# Technical Service Bulletin

**01 MIL on (DTCs P200400, P200500, P200600 and/or P200700) stored in ECM**

01 17 26 2048411/1 July 19, 2017.

**Figure 1.** Micro-encapsulated bolt (A24-11860 of repair manual).

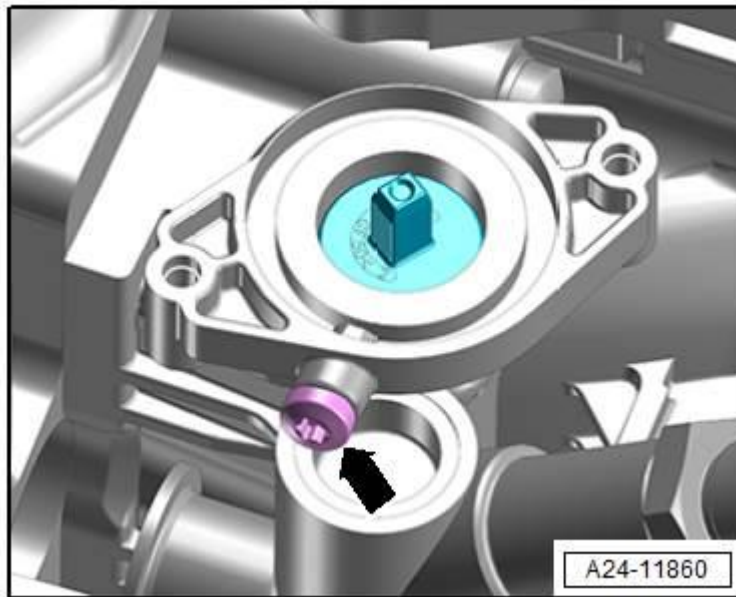
When replacing the potentiometer, the micro-encapsulated bolt of the potentiometer (Figure 1) must be replaced. The micro-encapsulated bolt is included in repair kit 079198135.

If the DTC is logged due to a fault of the vacuum regulator (bank 1 or 2) or the potentiometer for the intake manifold flap adjustment (bank 1 or 2, G336 or G512) and the vacuum supply of the intake manifold flap adjustment is not the cause, fit the repair kit 079198135 on both banks. The repair kit consists of one vacuum regulator, one potentiometer, and one micro-encapsulated bolt.
